**ENGINEERING, OPERATIONS AND PLANNING COMMITTEE MEETING  
AGENDA**

**DATE:** January 16, 2024  
**TO:** Engineering, Operations and Planning Committee  
**FROM:** Linda Jadeski, Assistant General Manager  
**SUBJECT:** CHANGE ORDER NO. 4 WITH PCL CONSTRUCTION, INC. FOR THE OLIVER P. ROEMER WATER FILTRATION FACILITY UPGRADE AND EXPANSION PROJECT

CHANGE ORDER

Order No. 4  
Date 1/8/2024  
Agreement Date 10/31/2022  
Sheet 1 of 2

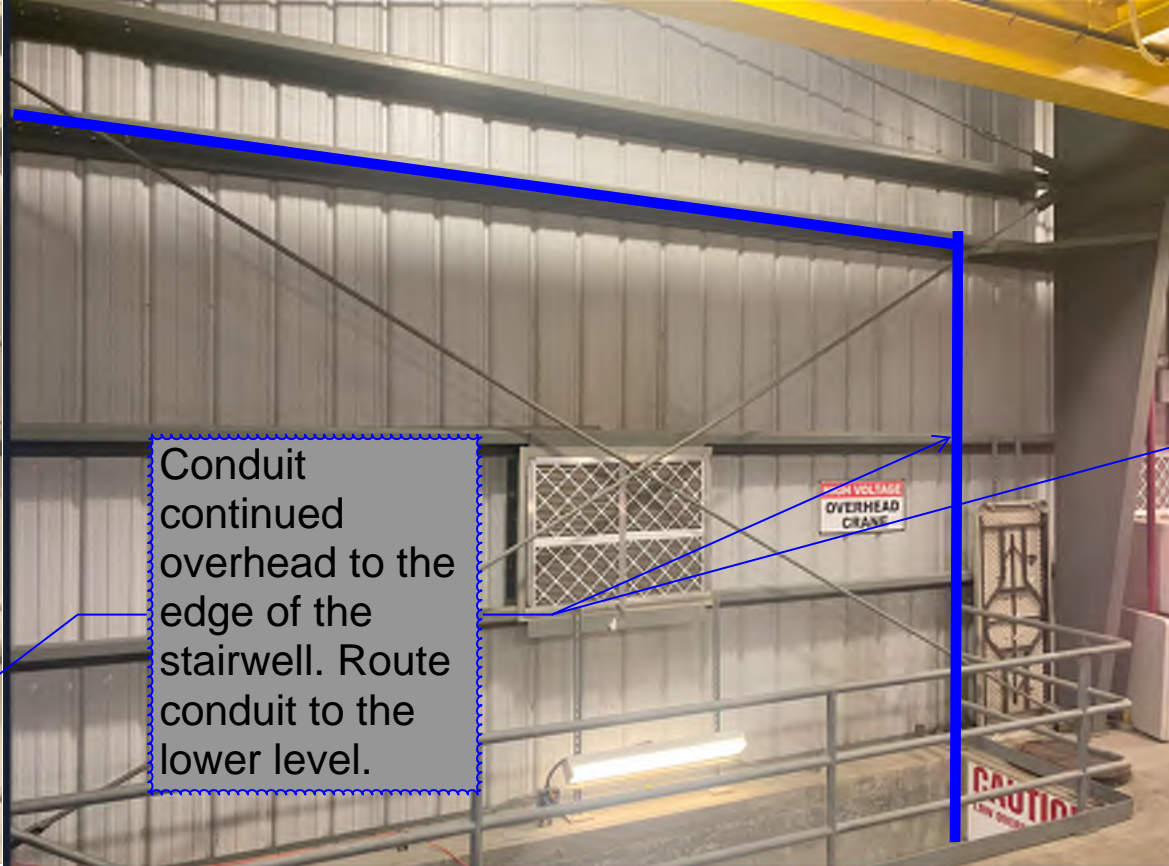
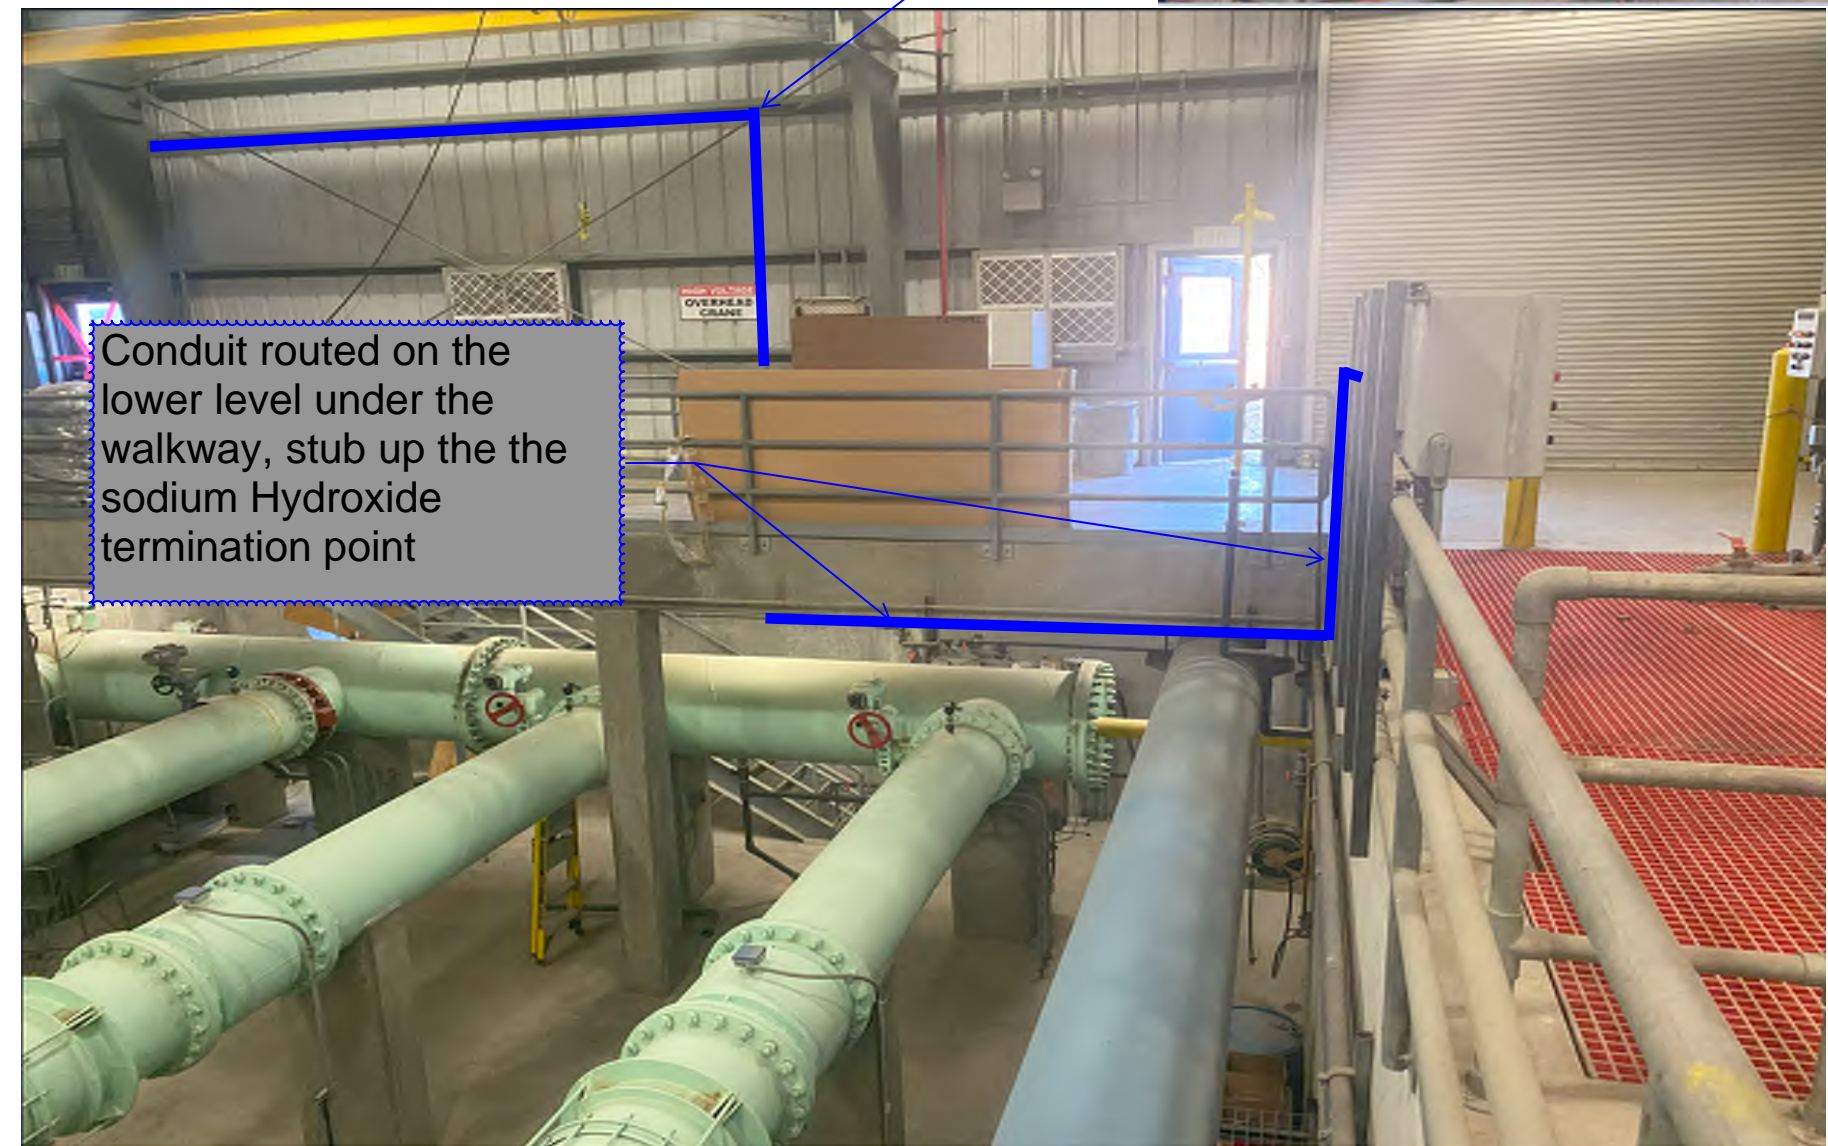
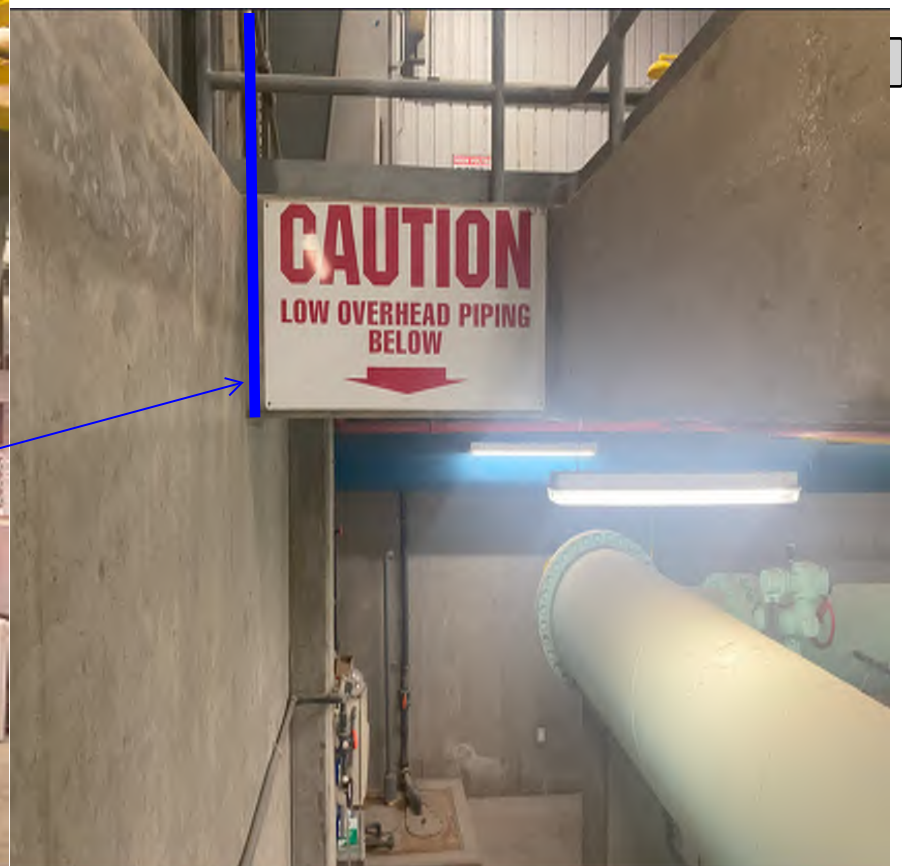
The Sodium Hydroxide conduit will need to be rerouted. Included in this package, there is a suggested routing plan as well as the proposed pricing for the reroute.

1" Conduit Ran out of the top of LP-E overhead along the wall.

Conduit continued overhead to the edge of the stairwell. Route conduit to the lower level.

Conduit routed on the lower level under the walkway, stub up the the sodium Hydroxide termination point

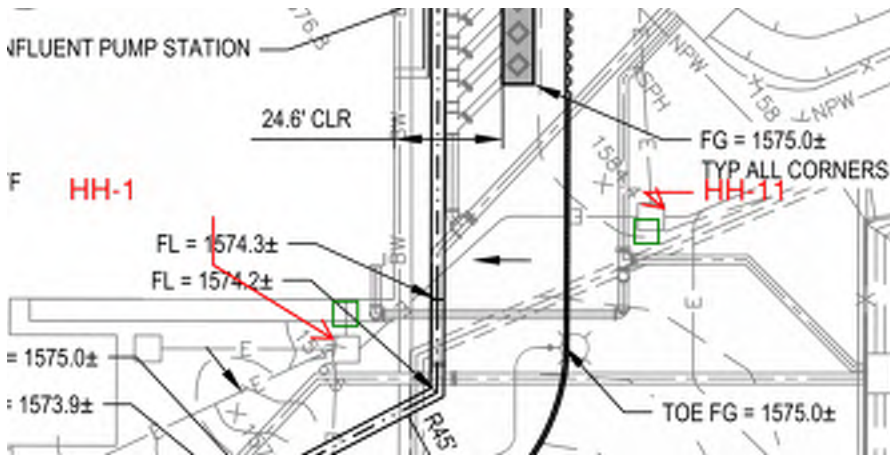
1. The existing ductbank's elevation is in conflict with the new retaining wall. Below is a rough idea of its elevation in relation to the new wall. The ductbank follows the slope of the existing hill.

- The two existing electrical vaults HH-11 and HH-1, with wires that feed the building, are at different locations, compared to what they are shown on the 30%. HH-11 is closer to the existing/new 24" tie-in point than what is shown on the drawings. HH-1 is closer to the building than what is shown on the drawings as well, which tells us that the existing ductbank would conflict with the new 24" UV reroute. See the screenshots below for additional information.
